Background Papers

Application A: Millennium Bridge House (20/00214/FULMAJ)

Comments for Planning Application 20/00214/FULMAJ

Proposal: Refurbishment and extension of the existing building involving the partial demolition and partial infilling of the existing structure and the introduction of a new facade to all elevations and extension to the building at all floors, introduction of roof terraces at fifth and sixth floors, including a public viewing terrace and associated lobbies at second and sixth floors, alongside a part change of use at ground floor from Office to Retail/Cafe/Restaurant/Bar (Class A1/A3/A4); a part change of use at first from Office to either Office or Retail/Restaurant/Bar (Class A1/A3/A4/B1); second floor from Office to either Office or Retail/Restaurant (Class A1/A3/B1) and a change of use from Office to Retail/Cafe/Restaurant (Class A1/A3); a part change of use at sixth floor from Office (Class B1) to either Office or Restaurant/Bar (Class B1/A3/A4) and a change of use from office to restaurant/bar (Class A3/A4) use together with public realm works to Peter's Hill (including the removal and relocation of the southern HSBC gates), Lambeth Hill, Trig Lane a

Figure1: sketch of Roadway showing proposed building on and around the Roadway

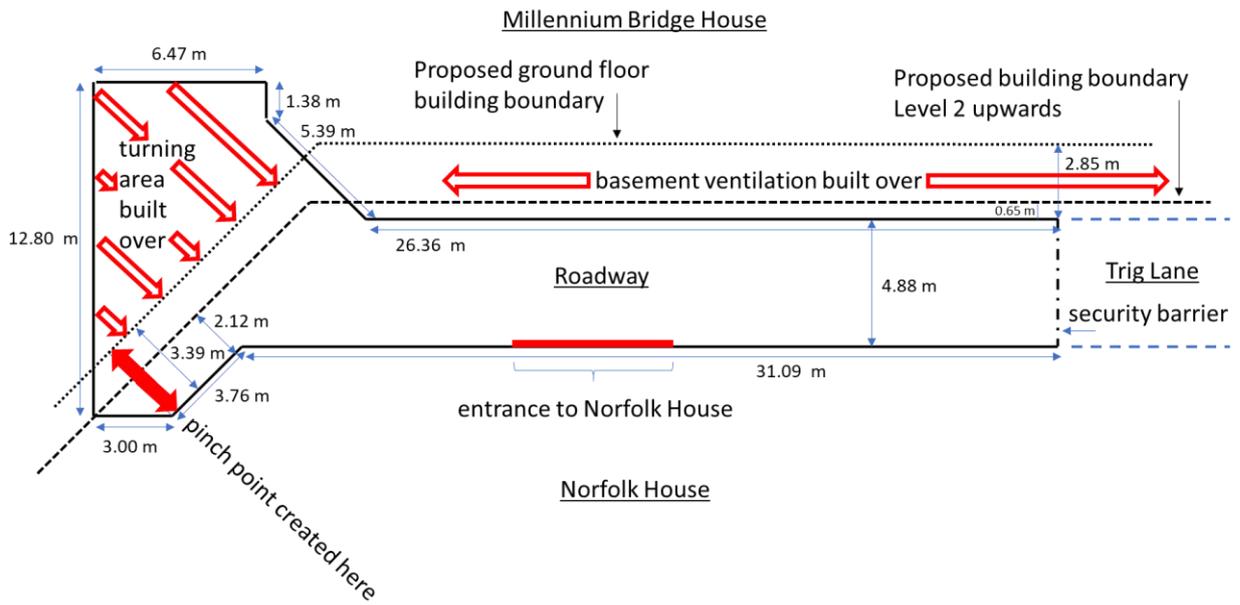
4a. No acceptable provision has been made by the Applicant to give equally convenient vehicular access to Norfolk House residents to load and unload directly in front of Norfolk House’s main entrance and to turn vehicles around within this roadway so vehicles can re-join Trig Lane in forward gear. We prepared a plan (Figure 1 below) and photographs (Figures 2 to 5) based on the Applicant’s proposal. This shows how the Applicant proposes to build over the turning area in the existing Roadway (which adjoins Trig Lane) in a way that will make it impossible for Norfolk House to continue to have equally convenient access and egress, even were the Applicant to propose including roadway access to the entrance to Norfolk House, which the Applicant has not done.

(Please note that Figures 1 – 5 were prepared informally by residents, to help visualise the Applicant’s plans, as contained in the Applicant’s presentation. We have tried to locate key points in these figures as closely as possible to the Applicant’s drawings although some dimensions were not given and which we estimated to locate key points. Any slight error in positioning should not detract from the observations we are making.)

(3) There are no changes proposed which would impact the ability for residents of Norfolk House to access the front door on foot or for deliveries. The existing arrangement is maintained despite the change in the ground floor building line of Millennium Bridge House.

In terms of deliveries, it is understood that vehicles typically drive forwards into Broken Wharf and then reverse into Trig Lane through the bollard. Further, it is understood that the legal rights given to Norfolk House do not provide for vehicles entering or exiting in forward gear and only provide access to the front door by foot or vehicle for loading and unloading only.

The proposals would not preclude access for residents on foot or by vehicle for deliveries and the width of the shared surface would be a minimum clear width of 4.9 m at its narrowest point. The design of the shared surface area along Trig Lane is a matter for detailed design and there could be scope to widen the roadway. The clear width from the existing planter to the proposed ground floor line along Trig Lane is 7.5m.

Figure 2 – Fire Access Arrangement to Norfolk House

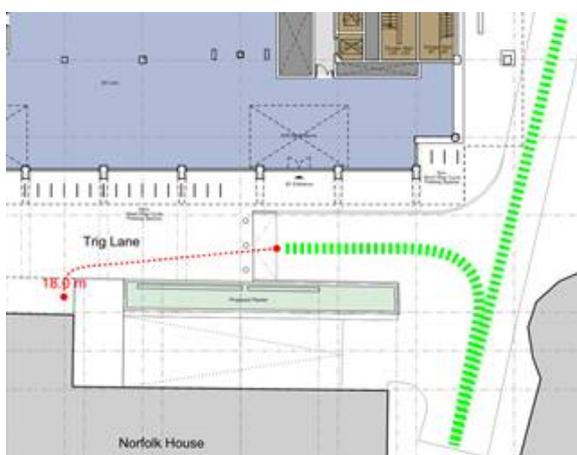
5c. By increasing the size of their building, the Applicant significantly reduces the already limited distance between the raised Podium of Norfolk House and their planned development. This expansion stops the Fire Brigade from not only efficiently accessing Norfolk House and the new development on the Thames side, but also the lower area of the Millennium Bridge and the adjacent school.

5d. Norfolk House residents would like assurance from the Fire Brigade that all fire safety aspects of this Application have been reviewed and deemed safe on fire safety grounds which are a concern for all high-rise residential buildings. This is not a frivolous demand. In the immediate area there are already three restaurants operating and several more are planned in the new development. Kitchens are one of the main sources of fires.

(5a.& b.) Fire service access will be available to within 18m of the dry riser inlet serving Norfolk House. Turning is available using the hammer head provided by Trig Lane and Broken Wharf shown at figure 2.

This arrangement is compliant with Building Regulations Approved Document B (Fire Safety) guidance.

Existing plan

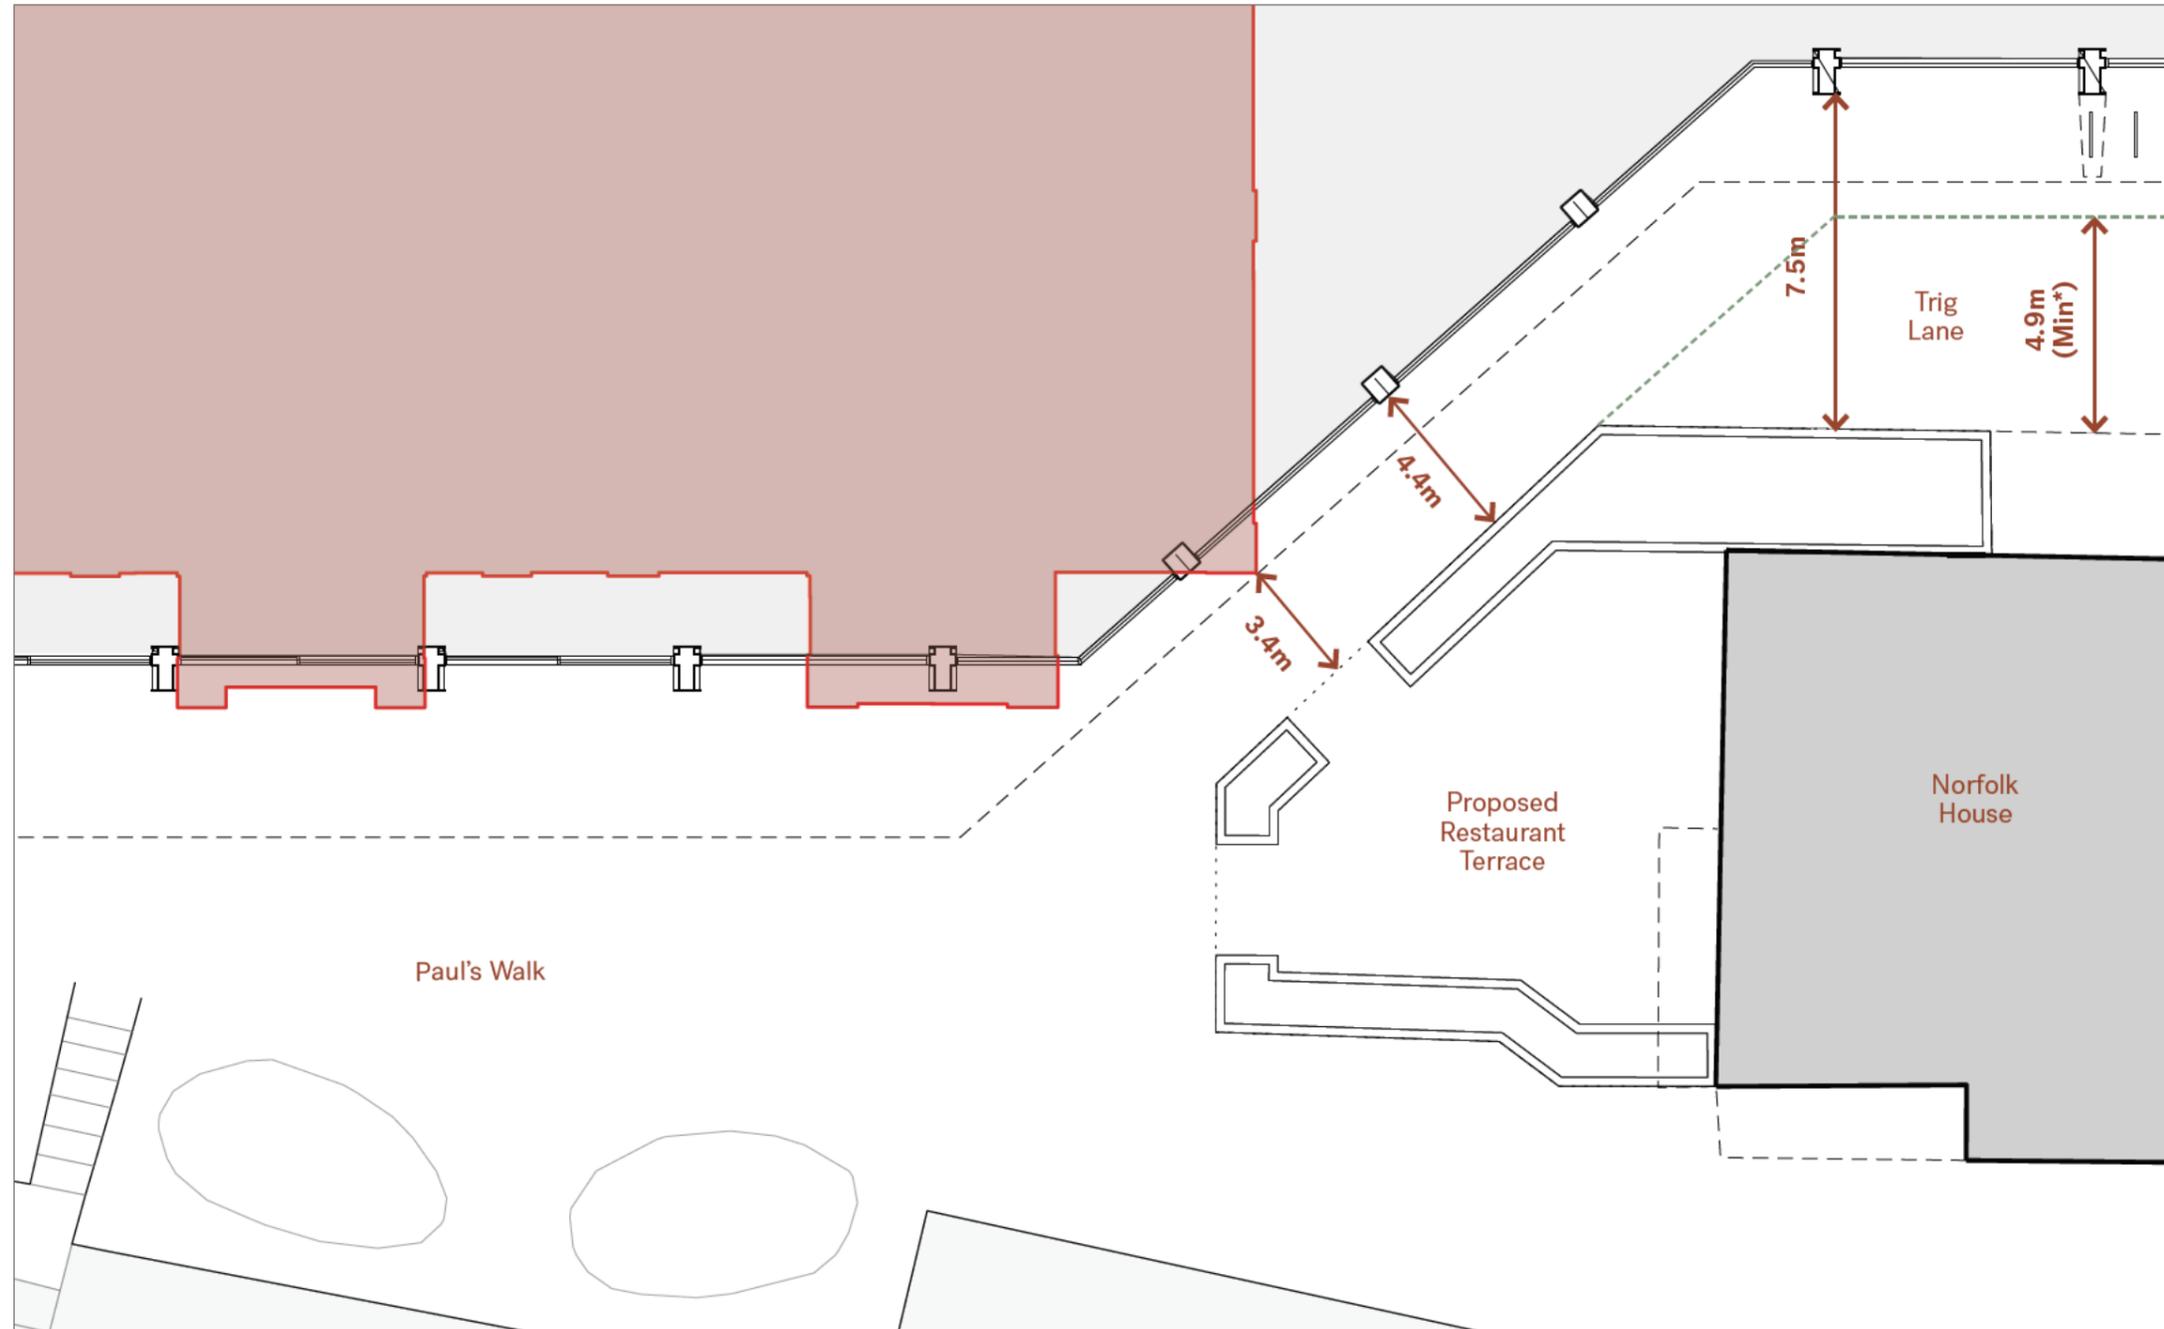
The proposed south elevation is an unrelieved cantilevered wall, substantially in advance of the line formed by the forward-most part of the currently castellated building line. This existing plan form was carefully articulated in the original design so as to provide interest in outlook, to manage the experience of enclosure and to moderate overlooking of the residential units.

Notwithstanding the change in building line, the repaving and enhancements to Trig Lane and Paul's Walk are considered to be acceptable and beneficial alterations. A minimum footway width of 4.4 m is maintained along the angled element, an improvement of approximately 1m on the current clear width.

In addition, by design, pedestrians are encouraged to use the Thames Path rather than Trig Lane and Broken Wharf. It is considered that the proposals provide sufficient width to maintain pedestrian comfort along Trig Lane in any case.

Flat 11

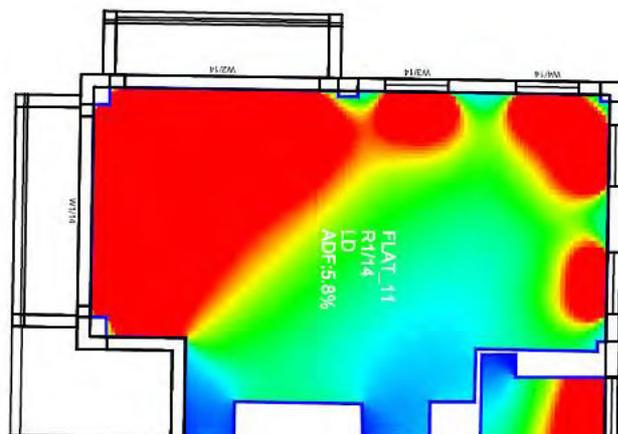
Where there is an open plan living space extending from the north to south elevations of Norfolk House, I have explained earlier why I do not think it is fair and reasonable to argue that the southern elevation glazing is the main source of light to the whole space. That is to ignore the impact upon the northern windows to these open plan spaces and I do not believe be correct.

1. There are six windows serving the LKD. The south facing window overlooking the River Thames is a full height, full width window measuring 4.5m x 3m. There is a second, equally sized windows that faces west. The north facing windows are 1.45m x 1.41m.
2. The existing VSC value for the south and west facing windows are significantly higher than the north facing windows. This fact, coupled with the larger window dimensions clearly dictates that the south facing window provides more daylight than the north facing windows.
3. The radiance plot below clearly demonstrates that much higher daylight factors are received through the river facing windows by comparison to the north facing windows. This is demonstrated by the brighter colours. The south facing windows are on the left of the image whereas the north facing windows are on the right.

It therefore seems clear to me that the south facing windows are the primary source of light and so I do not accept AH's suggestion otherwise.

Flat 1

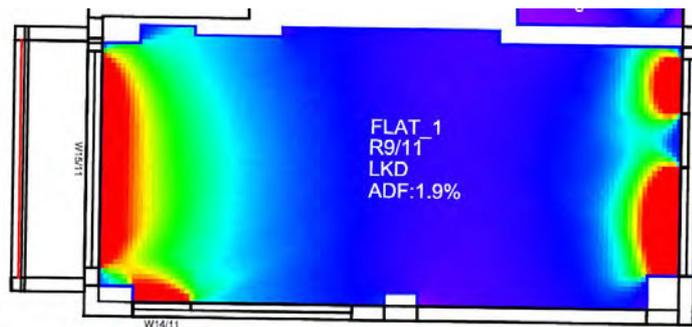
- This is an important point, because Point 2 make their initial assumption about the open plan arrangement and therefore effectively dismiss certain spaces as being BRE adherent when that may not in fact be the case. An example may be Flat 1 at first floor level.

1. The south facing window overlooking the River Thames is a full height, full width window measuring 4.5m x 2.275m. The north facing windows are 1.1m x 1.41m and 2.2m x 1.4m.
2. The existing VSC value for the south facing window is higher than the north facing windows.
3. The radiance plot below clearly demonstrates that daylight penetrates much further into the room through the river facing windows by comparison to the north facing windows.
